## Airworthiness and operational criteria for the approval of Electronic Flight Bags (EFBs)

CRD to NPA 2012-02 – RMT.0001 (20.002) – 31/07/2013

### EXECUTIVE SUMMARY

**FIGURE 1-1 ELECTRONIC MAP DISPLAY SYSTEM**

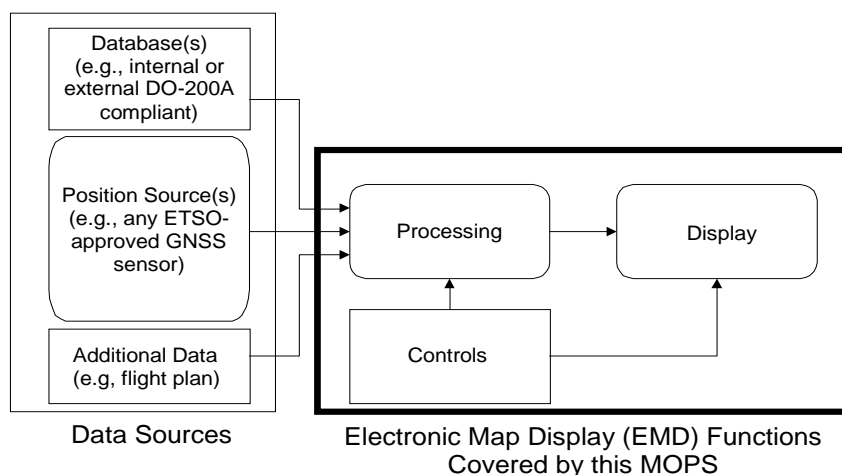
1.2.1 In page 3, Figure 1-1 has been replaced with:

In the new first paragraph, changes are underlined and deleted text is strikethrough:  
As an alternative to (or in addition to) an external data source, the EMD (as illustrated in Figure 1-1) may use an ~~internal~~ database to store information such as flight plans, nearby fixes, airspace boundaries, raster aeronautical charts, or airport mapping information. If an internal or external database is being used, the following requirements apply:
